Form 3160-5
(June 2019)UNITED STATES
DEPARTMENT OF THE INTERIOR
BUREAU OF LAND MANAGEMENTFORM APPROVED
OMB No. 1004-0137
Expires: October 31, 2021**SUNDRY NOTICES AND REPORTS ON WELLS**
Do not use this form for proposals to drill or to re-enter an abandoned well. Use Form 3160-3 (APD) for such proposals.

8. Well Name and No. ROSS DRAW 17 FED COM/712H

EOG respectfully requests an amendment to our approved APD for this well to reflect the following changes:

Revised Wellbore

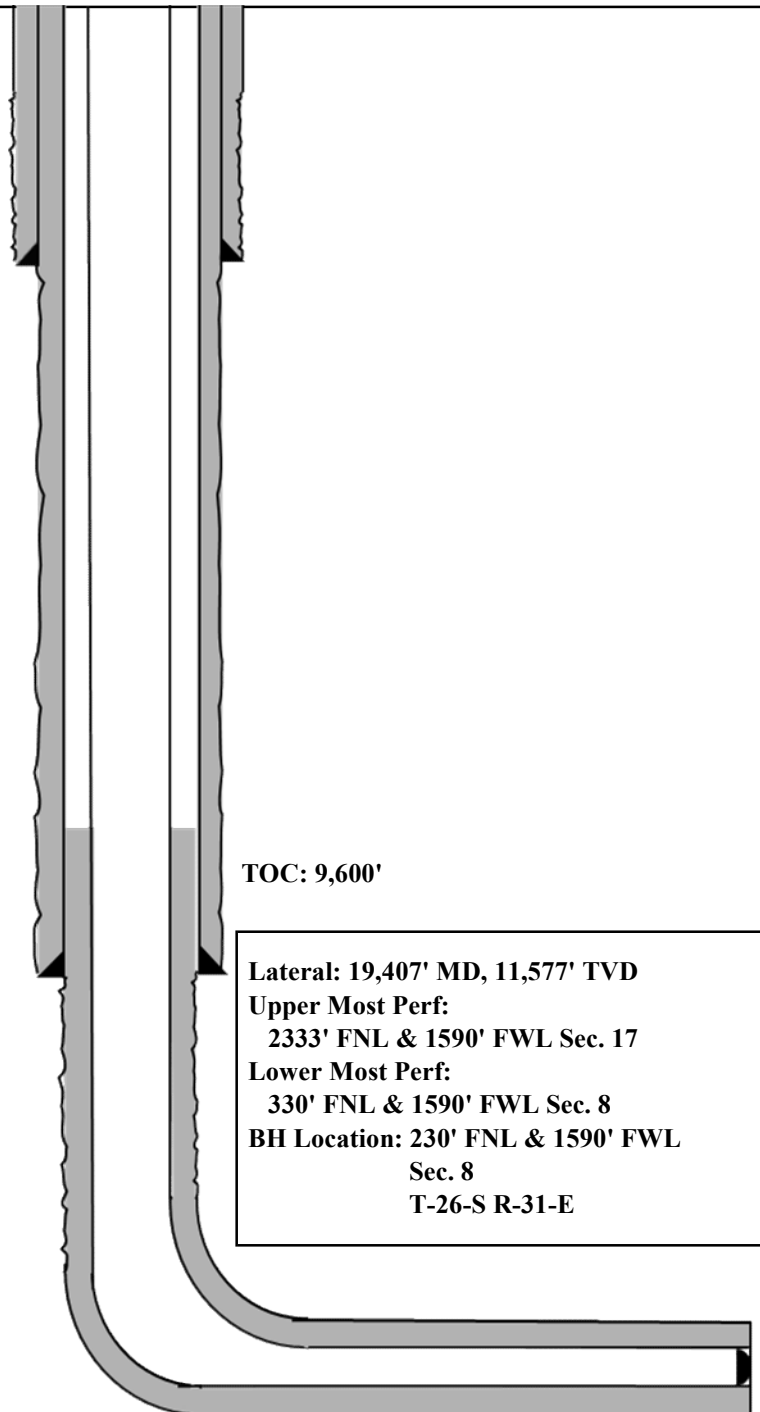
Change SHL from T-26-S, R-31-E, Sec 17, 2503' FNL, 1706' FWL, Eddy Co., NM, to T-26-S, R-31-E, Sec 17, 2462' FNL, 590' FWL, Eddy Co., N.M.

Change BHL from T-26-S, R-31-E, Sec 8, 230' FNL, 1310' FWL, Eddy Co., NM, to T-26-S, R-31-E, Sec 8, 230' FNL, 1590' FWL, Eddy Co., N.M.

Update casing and cement program to current design.

Bit Size: 8-3/4"
7-5/8", 29.7#, HCP-110, FXL,
@ 0' - 10,100'

Bit Size: 6-3/4"
5-1/2", 20#, P110-EC, DWC/C IS MS,
@ 0' - 9,600'

5-1/2", 20#, P110-EC, Vam Sprint SF,
@ 9,600' - 10,100'

5-1/2", 20#, P110-EC, DWC/C IS MS,
@ 10,100' - 19,407'

KOP: 11,228' MD, 11,100' TVD
EOC: 11,978' MD, 11,577' TVD
